## **BCA ASSESSMENT REPORT**

**Oakdale Central Lot 3, Buildings 3A, 3C and 3D  
Milner Ave Horsley Park**

**Client: Goodman Property Services**

Revision 5

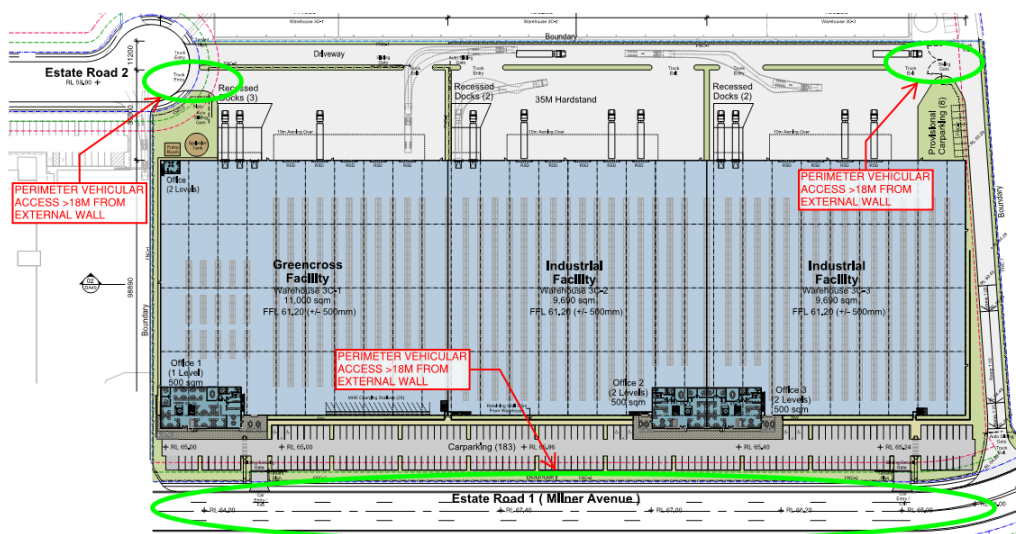
- + 3A -1 and 3A-2 – Vehicular Access is greater than 18m from the building; and the vehicular access is discontinuous in the NE corner of the building – see mark-up below.

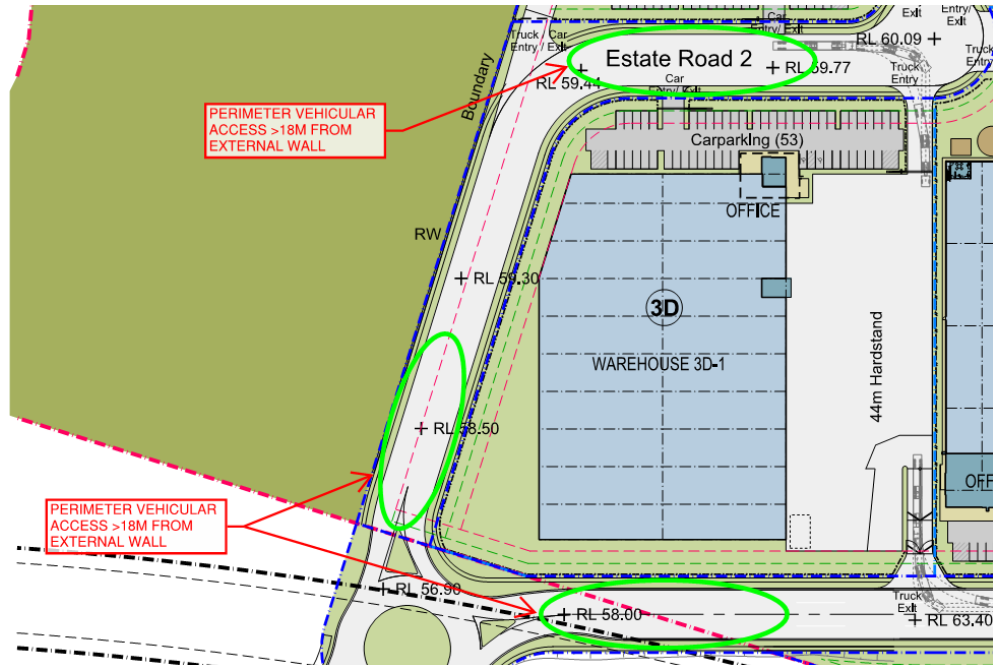
- + Lot 3C – Vehicular Access is provided on the southern side of the building via the Milner Ave which is greater than 18m from the building and the NW & NE corners of the building the vehicular accessway is also greater than 18m from the external wall of the building – see mark-up below.
